**Planning Committee**  
14 October 2015

**Report from the Strategic Director of  
Regeneration & Growth**

**Sudbury Court Conservation Area Design Guide  
Update – Consultation Responses and Proposed  
Amendments**

Chart A shows the response from properties within the Sudbury Court Conservation Area on the proposal for **infilling recessed entrances and porches** (nb numbers provided are actual numbers and not percentages)

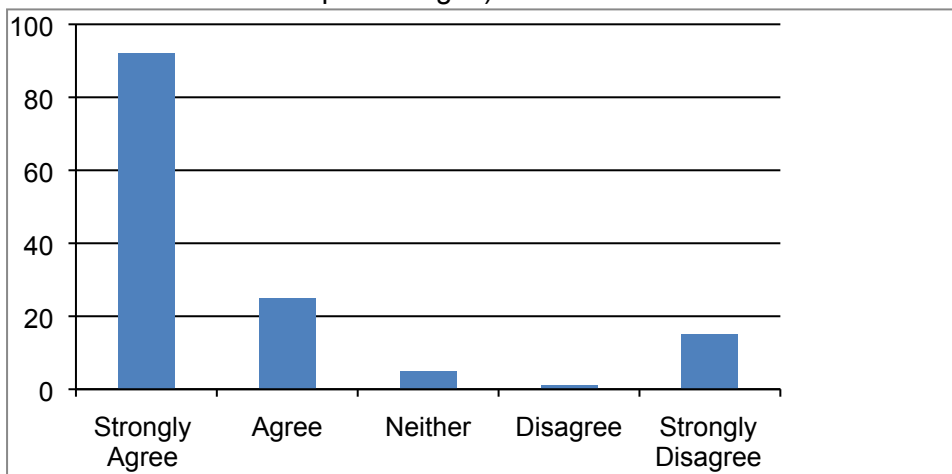
Consultation Responses	Discussion	Recommendation
<b>Porches and Canopies</b>		
<p><u>Resident's Comments</u></p> <p><i>Reasons why support and design suggestions:</i></p> <p>Infilling should be permitted to improve energy conservation; (x9)</p> <p>Infilling should be permitted to improve security; (x8)</p> <p>Exterior door to match the original style of front door within the porch; (x14)</p> <p>To be predominantly glazed to allow timber frontage doors to be retained; (x11)</p> <p>Porches to be wooden; (x4)</p> <p>Materials and colour to match existing house; (x1)</p> <p><i>Reasons why not support.</i></p> <p>Adversely impact on appearance; (x1)</p> <p>Should not be justified for energy efficiency reasons; (x1)</p> <p>Too many people get away with unauthorised works; (x1)</p>	<p>It is recognised that the recessed entrance porches and canopies contribute towards the special character of the Conservation Area. However, it is also evident that a large number of these features (around 64%) have been unsympathetically altered in the past.</p> <p>The results of the questionnaire also indicate that a large proportion of the respondents supported the infilling of recessed entrances as well as the construction of new wooden porches beneath an existing canopy.</p> <p>In both cases the original door should be retained or a sympathetically designed replacement installed to match the architecture of the house.</p>	<p>It is recommended that the Sudbury Court Design Guide is revised to include a section that allows the infilling of recessed entrances and porches.</p> <p>This is subject to it being of an appropriate design solution. For example, this includes the need for it to be predominantly glazed to allow views through to original features (such as the timber entrance doors and frame) behind.</p> <p>Where lost, there should also be a requirement to reinstate the original front door design to enhance the character of the building as a public benefit.</p> <p>The above approach to be applied to properties that already have a porch and are seeking to replace it.</p> <p>This is to allow uniformity in the design of porches and sustain and enhance the character of the conservation area.</p>

Chart B shows the response from properties within the Sudbury Court Conservation Area on the proposal for **replacement front doors in alternative materials to timber** (nb numbers provided are actual numbers and not percentages)

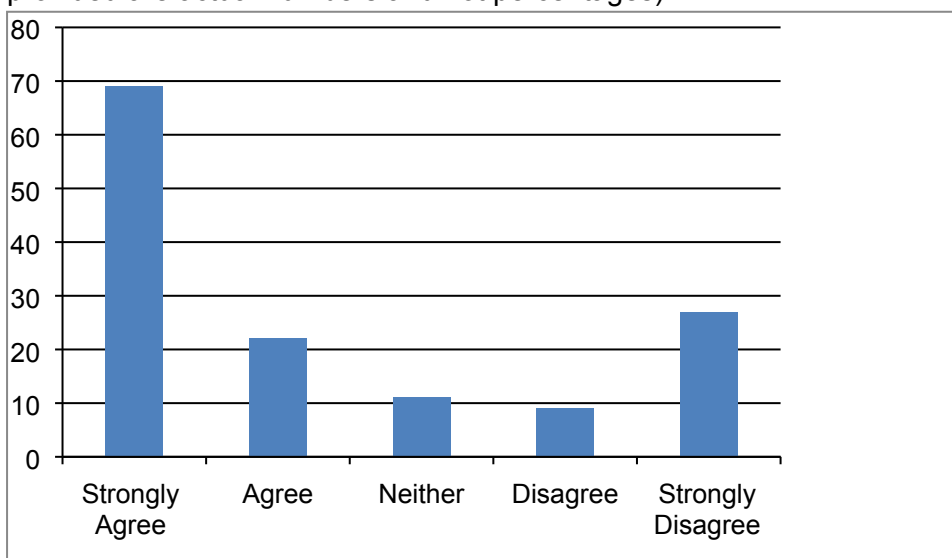
<b>Replacement Front Doors</b>		
<p><u>Resident's Comments</u></p> <p><i>Reasons why support and design suggestions.</i></p> <p>Energy Conservation; (x5)</p>	<p>A survey of existing properties within the conservation area indicates that of the properties that do not have porches, around 11% have replacement front doors in alternative materials</p>	<p>No changes recommended.</p>

<p>Security; (x4)</p> <p>Less maintenance; (x1)</p> <p>Replica design of the original style of door in modern material; (x14)</p> <p><i>Reasons why not support and design suggestions.</i></p> <p>Timber door more secure; (x1)</p> <p>Timber door more durable if maintained; (x1)</p> <p>Modern materials out of keeping with character of conservation area; (x1)</p> <p>Original front door to be retained if porch provided; (x1)</p> <p>Replace with timber door to match original style; (x2)</p> <p>Enforcement of such strict design guide with more support/residents association given more support and consultation.</p> <p>More enforcement is seen to be taking place by the Local Authority; otherwise the guide is null and pointless.</p>	<p>including PVCu and composite.</p> <p>It is considered that even the more modern doors in composite do not faithfully replicate the design and detailing of the original style of timber doors. This has an adverse impact and harms the character of the conservation area.</p>

Chart showing the response from properties within the Sudbury Court Conservation Area on the **proposal for roof extensions** (nb numbers provided are actual numbers and not percentages)

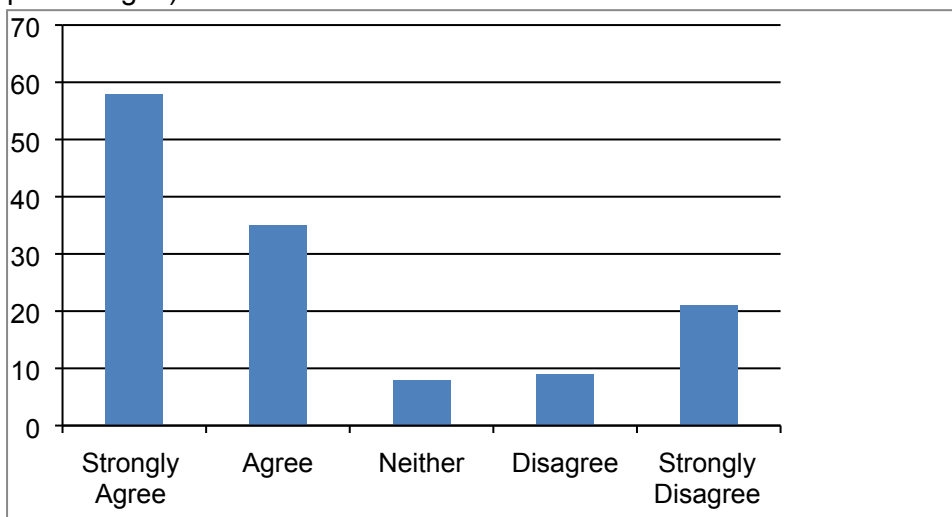
<p><u>Resident's comments</u></p> <p><i>Specific comments on type of roof extensions supported/not supported</i></p> <p>Support hip to gables generally; (x17)</p> <p>Support hip to gables with front roof lights; (x5)</p> <p>Supports hip to gables with no</p>	<p>The uniformity of the roofscape and gaps between properties forms part of the special character of the Sudbury Court Conservation Area.</p> <p>At present, only around 4% of properties have been extended with side dormer windows or hip to gable roof extensions.</p> <p>Allowing hip to gable roof extensions or side dormer</p>	<p>No changes recommended.</p> <p>If Committee are minded not to agree with this recommendation - by allowing such roof extensions - it would erode and harm the significance of the Sudbury Court Conservation Area to such an extent that it would not</p>
--	---	--

<p>front roof lights; (x7)</p> <p>Supports hip to gables on shared driveway properties; (x1)</p> <p>Supports side dormers; (x17)</p> <p>Does not support hip to gables; (x4)</p> <p>Does not support side dormers; (x7)</p> <p><i>Reasons why roof extensions supported</i></p> <p>Increasing house prices and extended family; (x4)</p> <p>Hip to gable will allow uniform roof design if applied throughout the estate; (x1)</p> <p><i>Reasons why roof extensions not supported</i></p> <p>Out of character; (x2)</p> <p>First floor side and rear extensions should only be allowed; (x6)</p> <p>Rear dormers only; (x6)</p>	<p>windows will have a significant impact on the appearance of the houses, altering the original roof form and reducing the gaps between the properties. Many are semi-detached and symmetrical. Such roofs extensions will harm the original proportions, design and character of the houses and therefore the streetscape - to no public benefit.</p>	<p>be worth pursuing its protection as a conservation area.</p> <p>In such instance, it will be recommended that the Sudbury Court Conservation Area is de-designated.</p>
